TO: HONORABLE CHAIRMAN AND PLANNING COMMISSION  
FROM: RON WHISENAND, COMMUNITY DEVELOPMENT DIRECTOR  
SUBJECT: CONDITIONAL USE PERMIT 06-009 (BRUCE WHITE)

DATE: NOVEMBER 28, 2006

Needs: For the Planning Commission to consider an application filed by Bruce White for a Conditional Use Permit to convert the existing house (Bldg. A) into a professional office and to remove the existing detached garage/shop building (Bldg. B) and reconstruct a building in its place that would have a professional office on the lower floor and a studio apartment on the second floor.

**Exhibit A**  
**Site Plan**  
**CUP 06-009**  
**(Bruce White)**

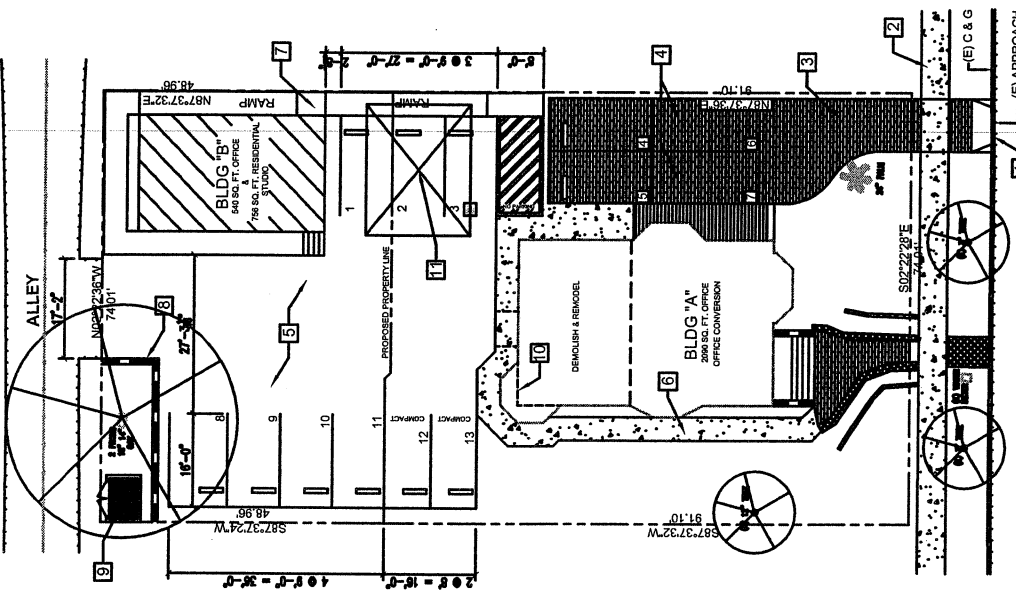
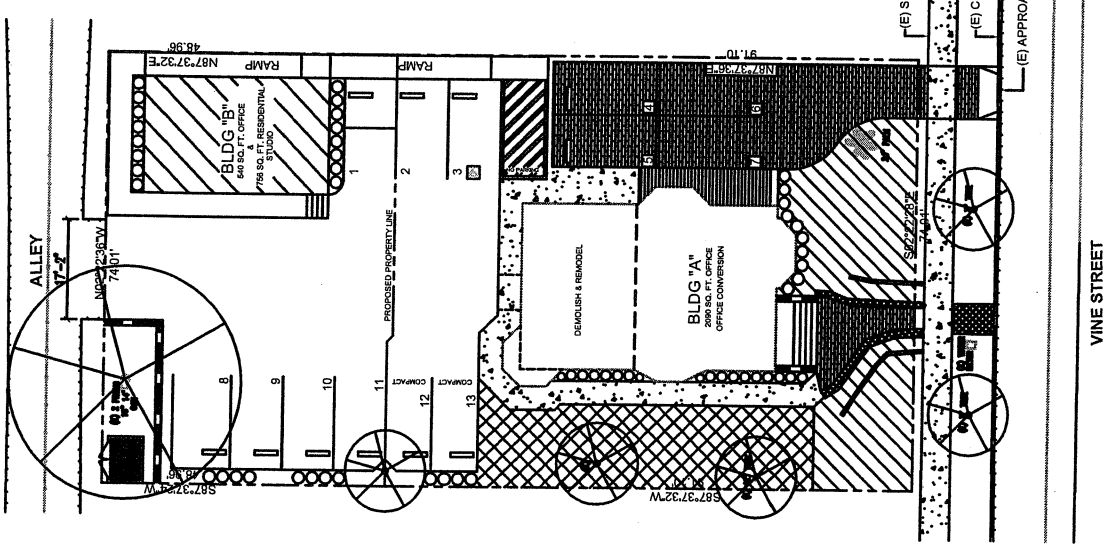
6. Of the 13 parking spaces shown on the proposed site plan, the applicant is requesting that the Planning Commission approve the use of tandem parking for the project. The request is to utilize the existing driveway off of Vine Street for two sets of tandem parking spaces (for a total of 4 spaces). See additional analysis on the tandem parking issue in the Analysis and Conclusions section in this staff report.

10. The trash enclosure for the project is proposed to be located within the drip line of the oak trees and shown to be constructed of wood in an attempt to lessen the impact to the oak trees. Since trash enclosures are required to be decorative masonry, the enclosure will need to be moved elsewhere on site.

Regarding tandem parking, the project requires 15 parking spaces based on the amount of square footage of office and residential uses that the applicant is proposing. While the request to share the two parking spaces for the residential unit, and only require 13 spaces for the project, would seem appropriate and consistent with Planning Commission's actions on other mixed use projects, the request to utilize four tandem parking spaces was a concern that was discussed at the DRC meeting.

The Parking Ordinance does allow the Planning Commission to approve the use of tandem parking, when the Commission can make the finding that the tandem parking is appropriate for the specified use. A majority of tandem parking that the Planning Commission has approved has been for residential uses. In this case, for a professional office use, where you may have employees and customers using the parking, the logistics of having a car parked behind a car that needs to get out of the lot has been discussed in the past by the Planning Commission as not being appropriate.

WHEREAS, as a result of having four tandem parking spaces for an office professional use it would allow the opportunity to be conflict between the parking for the employees and the parking for the customers, and therefore would not be appropriate.

9. Prior to the issuance of a Building Permit, the office building square footage will need to be reduced by 400 square feet so that the project can be reduced by two parking spaces.

12. Prior to the issuance of a building permit, the site plan needs to be submitted for staff review, relocating the decorative masonry trash enclosure out of the oak tree drip line.
